**PROPOSED CARE HOME:
DANSON ROAD, BEXLEYHEATH**

TECHNICAL NOTE

**REPORT REF. 190320-06
PROJECT NO. 190320
MARCH 2021**

Figure 2.1: – Redirected Proposed Departing Vehicles AM Peak Hour

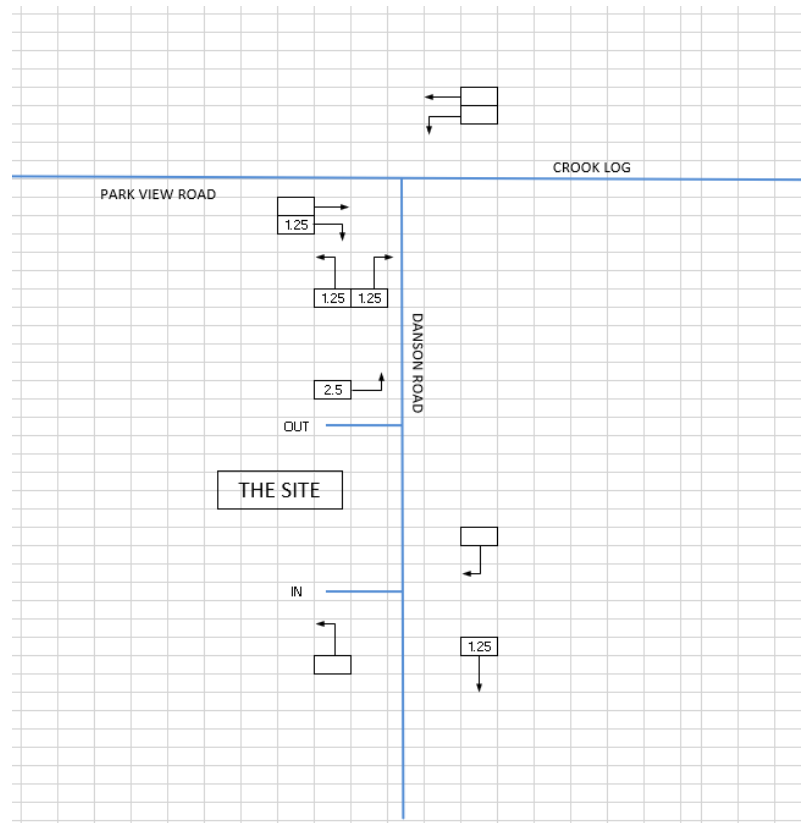
"• *The assignment of the above vehicle movements at the site's access and egress points and on the adjacent highway based on the assumption of a 50/50 split of north-south traffic on Danson Road (in line with the approximate proportional flow observed in the 2006 traffic survey mentioned by Peter Boulden at the meeting) and an assumed 50/50 split of traffic east-west at the Danson Road/Crook Log signal controlled junctions. Diagrams should be provided for the AM and PM network peaks together with the development peak hour;"*

- 2.18 The above figure indicates that a total of up to 3 vehicle exiting movements may need to be redistributed onto other routes in the AM peak hour in order to head south.
- 2.19 **Figure 2.1** indicates that this could occur either via vehicles turning left into Park View Road and turning in one of the surrounding residential areas, and then coming back to the signal junction to turn right. Or alternatively, by turning right at the lights and taking a route via Dallin Road.
- 2.20 As can be observed, the level of such traffic movements is very small, and this is during the peak operation hours of the carehome. At other periods such movements will be even smaller.

Drawing Title:
PROPOSED INTERNAL ARRANGMENTS

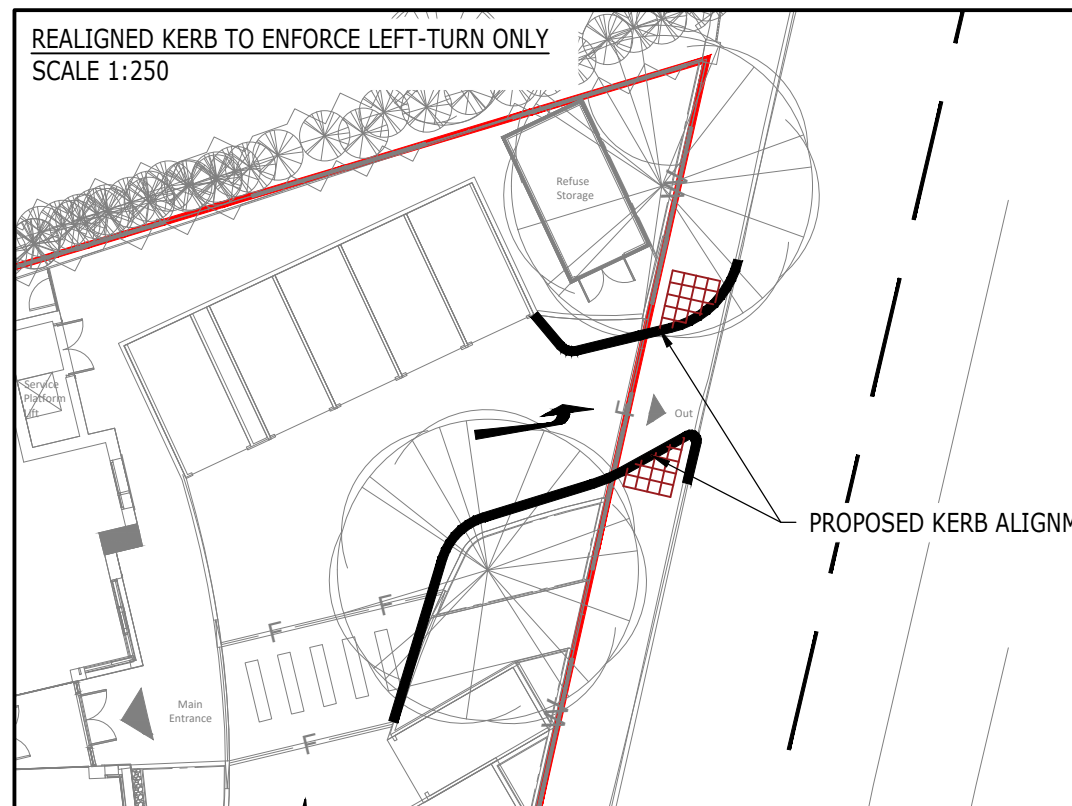
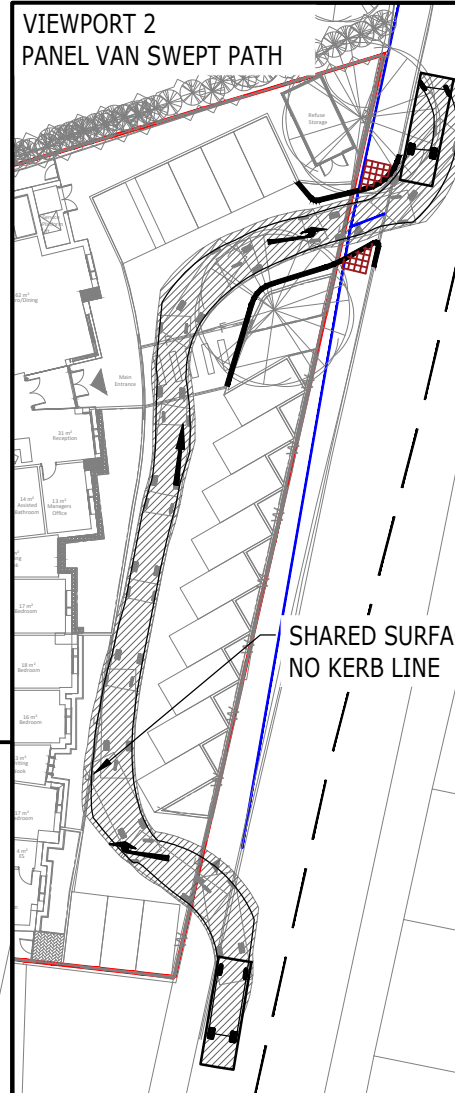
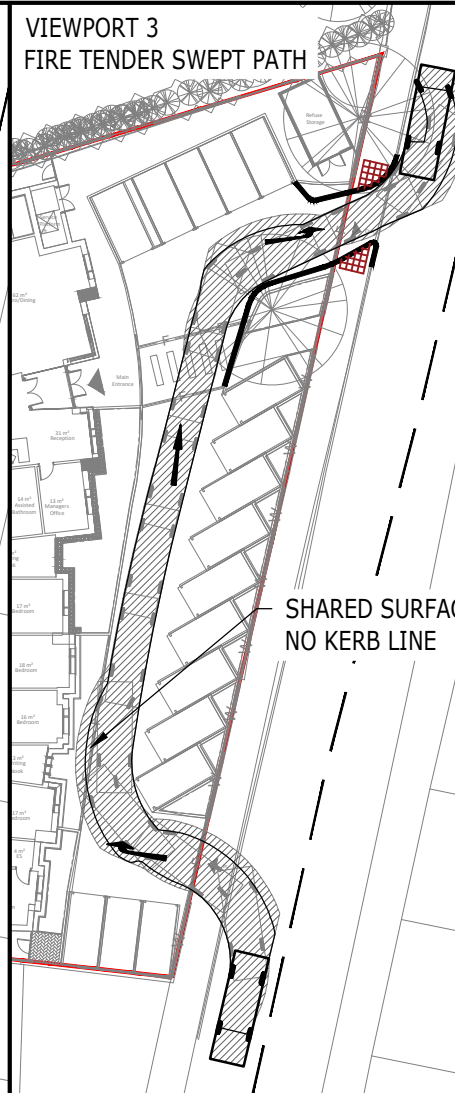
"• Further consideration how the banning of right turns from the site will be prevented and enforced, other than by a formal Traffic Management Order under highway legislation;"

- Kerb alignment to position vehicles so that a right turn is made difficult as shown on **Drawing 190320-004 Rev B**;
- Provide signage to advise of the left only turn out of the site;

REALIGNED KERB TO ENFORCE LEFT-TURN ONLY
SCALE 1:250
